Land & Fire Assessments Pty Ltd

Our Ref: LFA18020_TSA RFI response
Your Ref: TSA-RFI-000104

Response to TSA-RFI-000104 - Request for additional information DPE

Figure B. Implementation of the 50 and 67m APZ in respect to the identified hazard, which includes the vegetated portion of Lot 3, while the cleared portion of Lot 3 where considered as ‘rural managed vegetation’

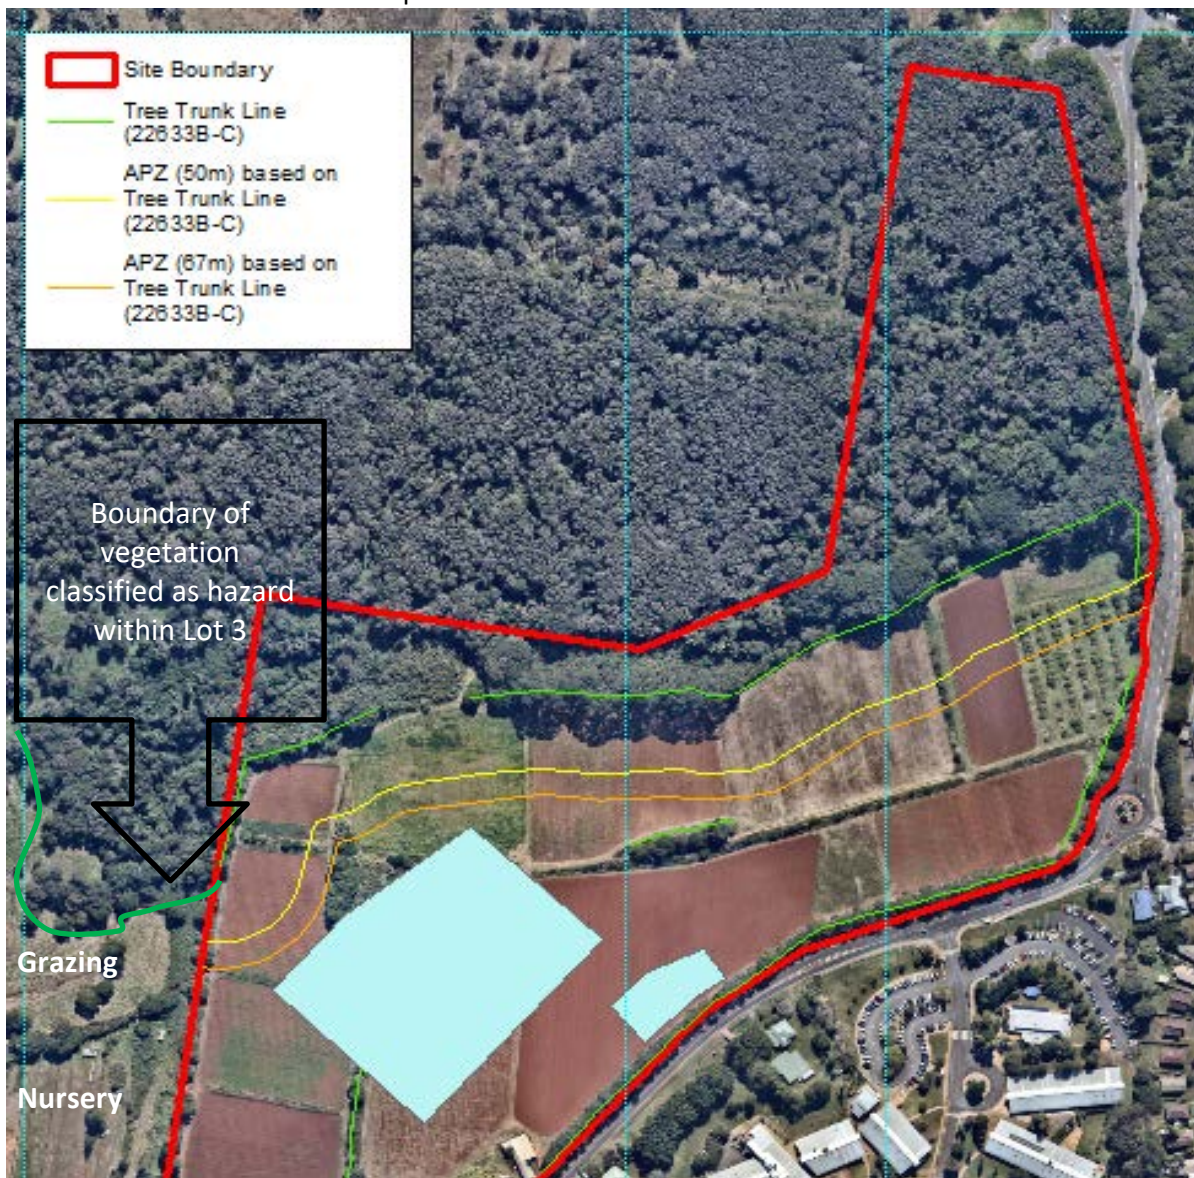
The bushfire report states that a 50m APZ would be needed. The building maintains a 67m APZ on the northern side. The submitted documentation identifies a maximum setback of 43 metres from the main hospital building to the western boundary of adjoining lot 3 DP 828298.

The Bushfire Assessment Report, follows the prescriptions of both PBP 2006 and the Pre- Release PBP 2018 and identifies the vegetation considered to be the classified hazard (refer to Fig. 4 in the Bushfire Assessment Report as reproduced in Fig. A). The land immediately west of the site was assessed as 'Rural- Managed Vegetation'; this applies to the commercial nursery on Lot 6 DP 727425 and the cleared portions of Lot 3 DP828298 immediately to the west of the hospital site.

The remainder and vegetated portion of Lot 3 DP828298 was classified as the Hazard (as shown in Fig. A). APZs are accordingly not required from the land considered “managed”. To date, the RFS have not disagreed with this assessment. The Bushfire Assessment Report does not prescribe anywhere that an APZ of 43m has been proposed on the north-western side adjoining mapped vegetation. The report states that ‘A 50m wide setback (APZ) from the classified vegetation edge within the Project Site to the proposed building (or buildings) will be required as shown in Fig. 5. This APZ has been reflected in the Masterplan design shown on Appendix A.’ In addition, provision was also made to accommodate a 67m wide APZ. The 43m setback identify by DPE is simply the setback that has been implemented by the team designing the hospital, but is not an APZ. The following Fig. B shows the implementation of the 50 and 67m APZ in respect to the identified hazard. It can be seen in Fig. B that ample allowance was made in the consideration of what constitutes the hazard and that the neighbouring land to the north west corner of the hospital is cleared and has been cleared since at least 2003. This point will be discussed in more detail as follows.

Figure D. TLEP 2000

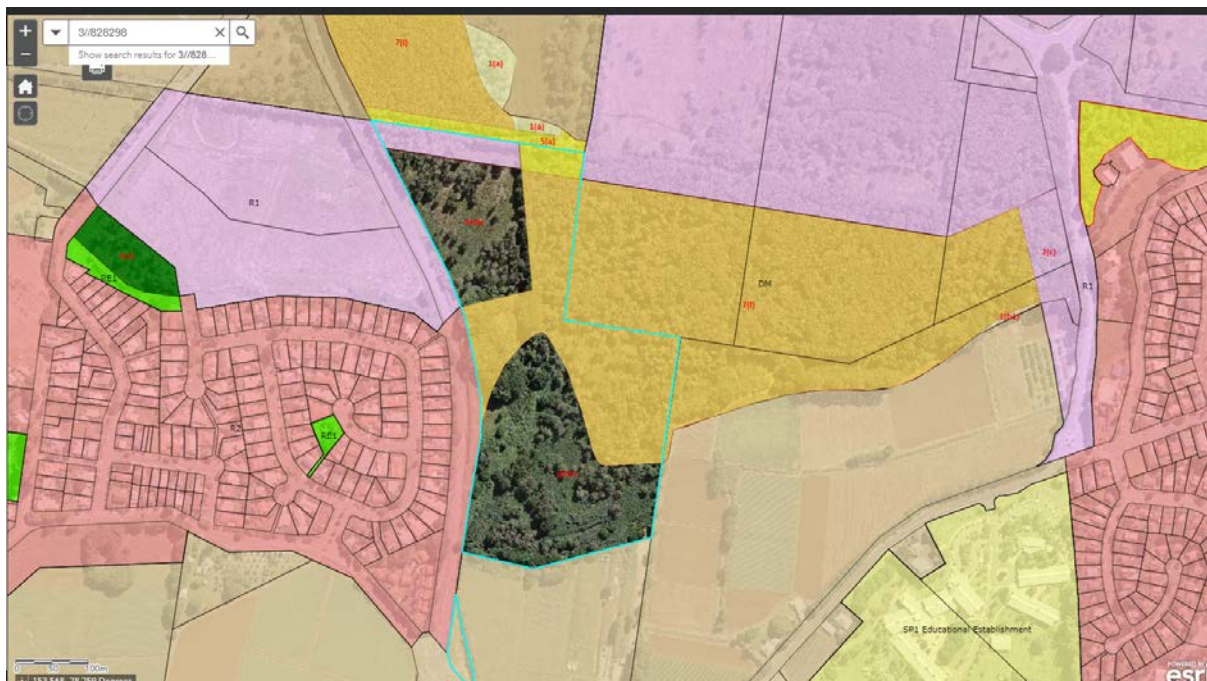
The vegetation on adjoining lot 3 to the north-west is part mapped Coastal Wetlands under the Coastal Management SEPP and it could be considered as an unmanaged wetlands vegetation formation (if revegetated in the future).

Based on Tweed Shire Council LEP mapping, Lot 3 DP828298 includes zones under both the TLEP 2000 and TLEP 2014, with a large area noted as 'defer' and no zone identified for this area under either LEP. The mapping as shown on Fig. D shows the zones or deferred matters applicable to this lot (light blue boundary).

Additionally, the Tweed Council Shire (TSC) mapping identifies the south eastern and south western portions of Lot 3 DP828298 as 'Farmland Protection project' as shown on Fig. E (the lot in question is bound by light blue line). In subsequent layer this same portion of the site (i.e. Farmland Protection) is deemed as 'Arable land suitable for regular cultivation of crops'. Given this information, it would be unreasonable to assume that this land would change from its current land use.

Despite the fact that the land may be mapped as Coastal SEPP (since April 2018), current mapping (eg. TSC mapping shown on Fig. E, Appendix C of Tweed Valley Hospital Agricultural Impact Assessment shown on Fig. C) as well as the clearing history (refer to Appendix A) indicates that Lot 3 is identified for rural agriculture and the landuse is accordingly identified as grazing/cultivation.
